The following items are revisions and clarifications to the tender documents. Revisions to the drawings are outlined in structural sketches that are attached with this addendum. A revision number located within a triangle denotes changes to the drawings.

END OF STRUCTURAL ADDENDUM #S01

PROJECT	PROPOSED 12 UNIT EXTENSION MILLS SUPPORTIVE HOUSING
DRAWING	MASONRY NOTES (REF: S000)

DRAWING No.
ADD-S01
SK1

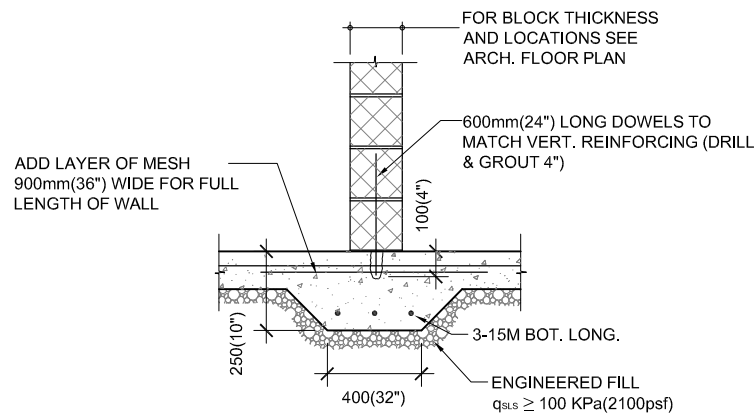
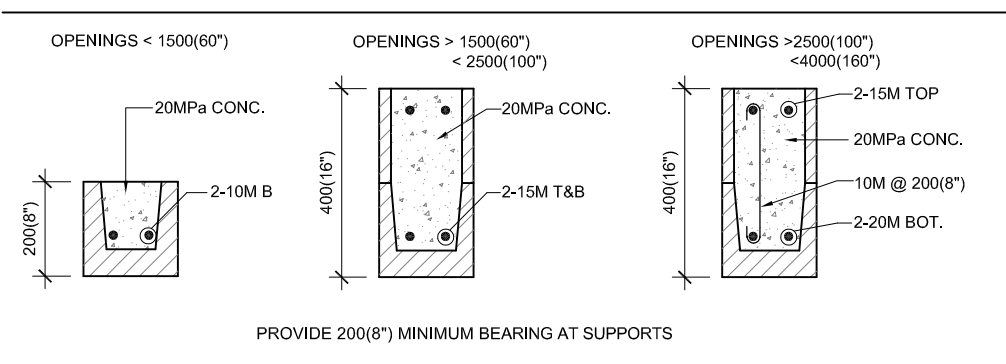
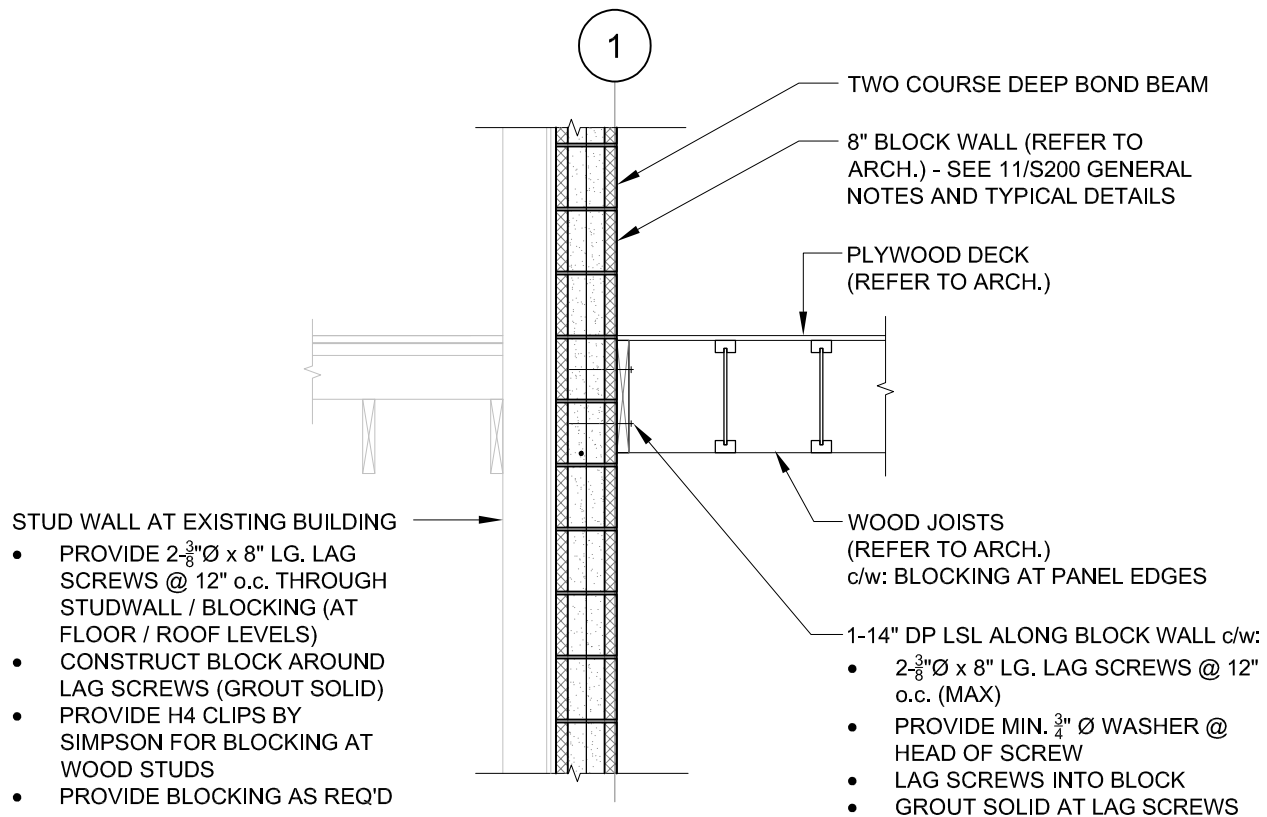
1. Include Masonry Notes in General Notes and Typical Details to drawing S000; refer to sketch ADD-S01-SK1.
2. Double steel stud wall along gridline 1 to be replaced with an 8" block wall for fire separation. Refer to sketches ADD-S01-SK2 and ADD-S01-SK3 for details.
